Marulan South Limestone Mine Continued Operations State Significant Development Application

RESPONSE TO SUBMISSIONS

Prepared for Boral Cement Limited | September 2019

The public authority submissions are addressed in this chapter. **Bold** text is an exact reproduction of the submissions received, while normal text is Boral's response to submissions.

Figure 6.11
Project area overlap for Marulan South Limestone Mine and Peppertree Quarry Modification 5

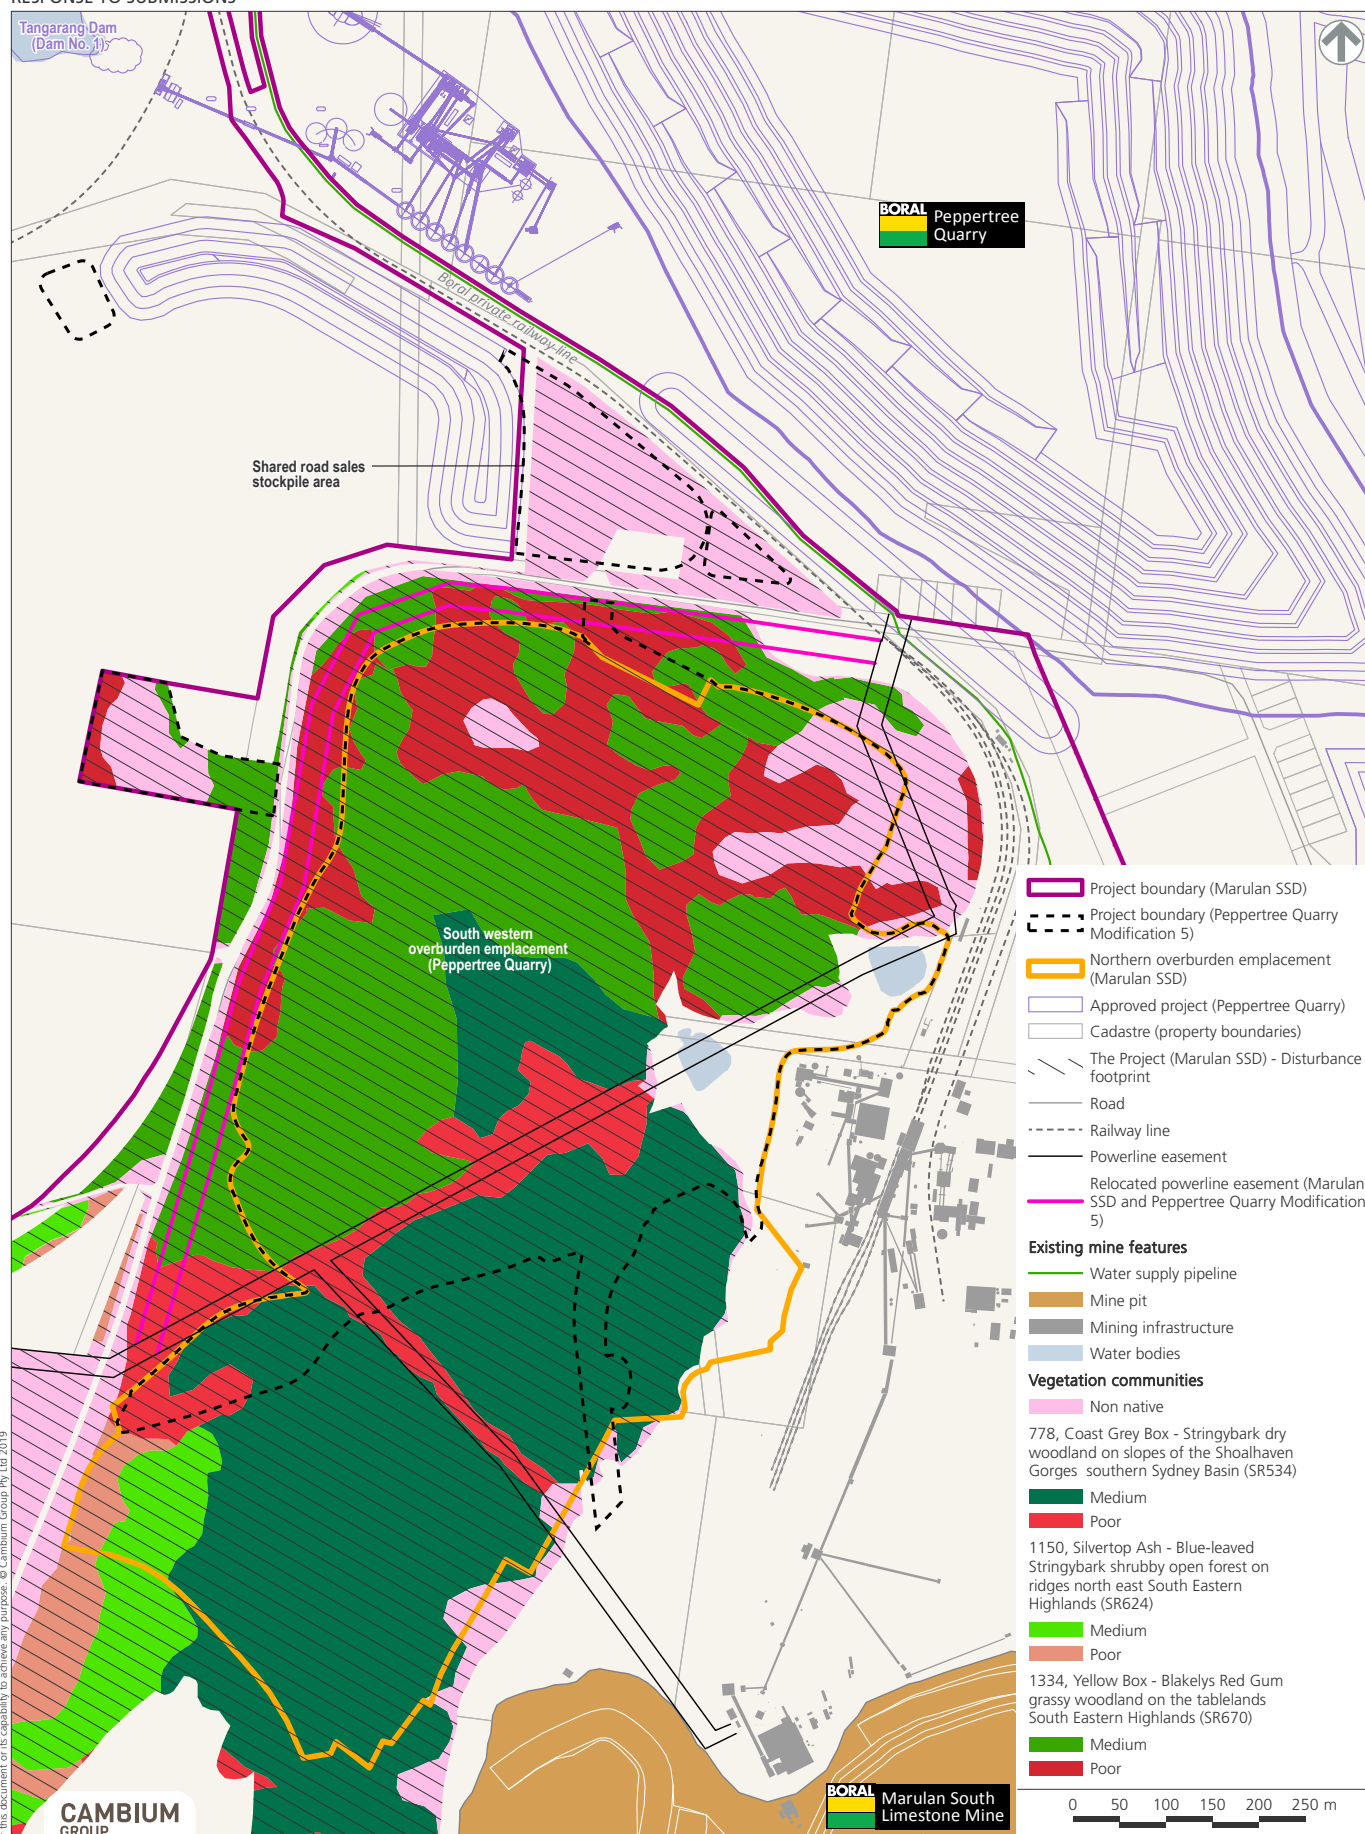
The Office of Environment and Heritage (OEH) has raised concerns regarding potential biodiversity impacts associated with the drawing of water from Tallong Dam. The Department notes that the Biodiversity Development Assessment Report (BDAR) may require revision, after item (1) above has been clarified.

The offset calculations in the EIS included the northern overburden emplacement, which appears in the environmental assessment for Peppertree Quarry Modification 5 as the south-west overburden emplacement. The overlap of these emplacements is shown on Figure 6.11. Therefore, offset credits for biodiversity impacts in this area have been included in both assessments. The Peppertree Quarry credit requirements have been subtracted from the mine's credit requirements in this section to clarify the required biodiversity offset requirements for the mine.

Figure F-1 Comparison of Predicted Neutral Noise Levels & Measured Mine Operational Noise using BarnOwl for 29 March 2015

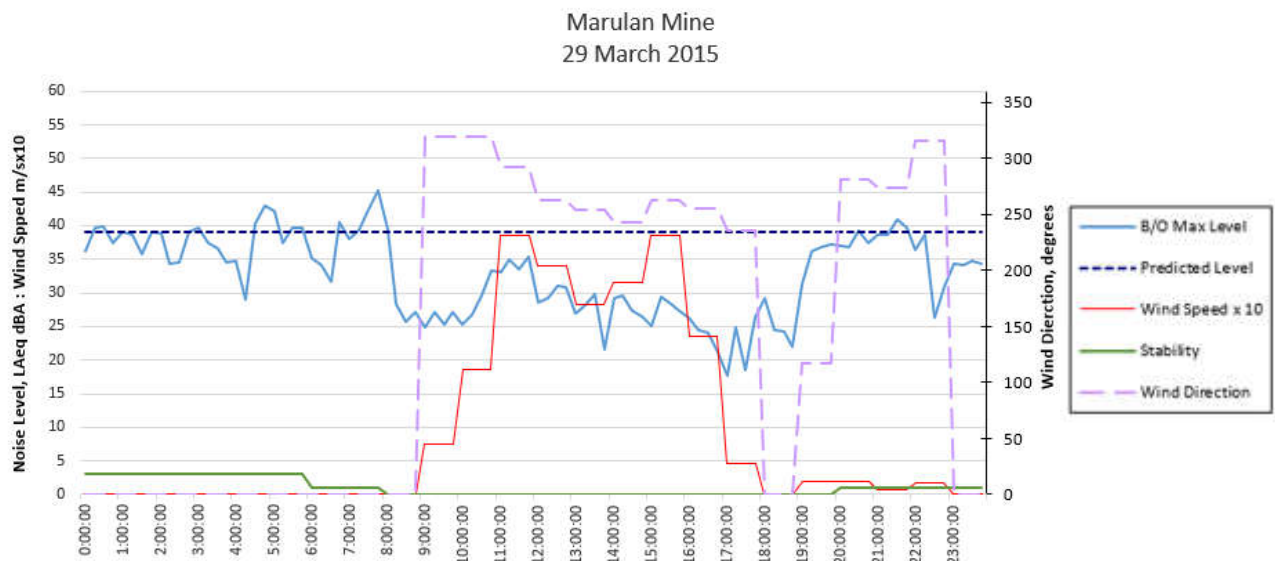
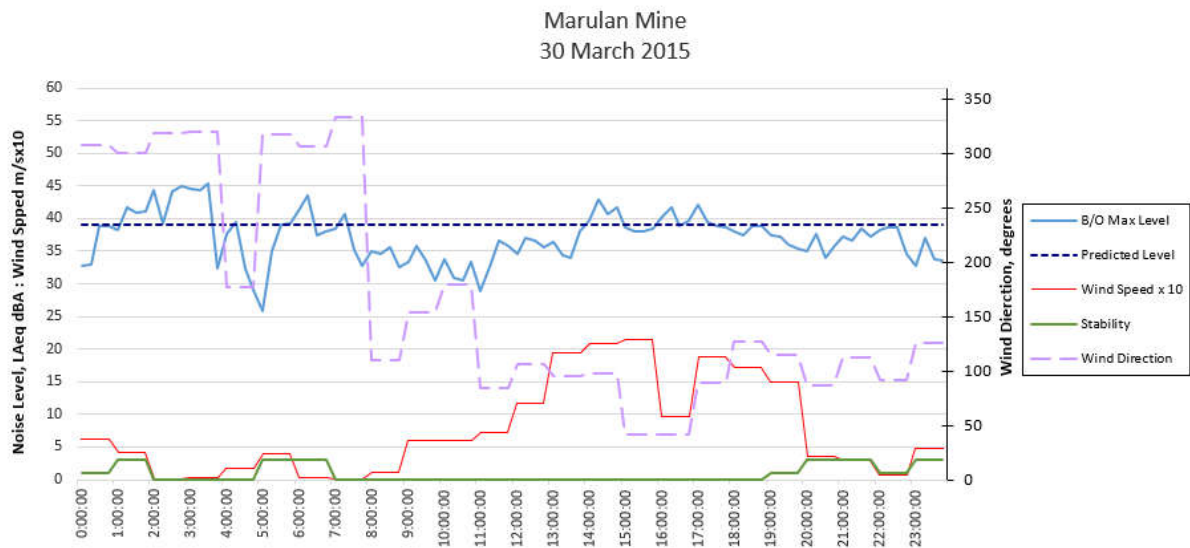
- a. clarification regarding the assessment of meteorological conditions;
- b. further explanation regarding predicted noise levels, and whether these predictions represent worst-case noise impacts for Receivers R9 and R12;
- c. that the relocation of the stockpile reclaim area and construction of the road sales stockpile area be included in the operational noise assessment, rather than the construction noise assessment; and
- d. demonstrated validation of the noise model.

In order to validate the site noise model, the noise predictions for the Marulan South Limestone mine under neutral meteorological conditions using the ENM noise prediction algorithm was compared to the measured BarnOwl data. The comparison of the measured noise levels and predicted noise level using neutral conditions are presented in Figures F-1 to F-3.

The predicted noise levels under neutral conditions are generally less than the measured levels with an occasional higher level that is no greater than 5dB. As such, it is considered that the ENM noise prediction shows good correlation with the measured noise levels.
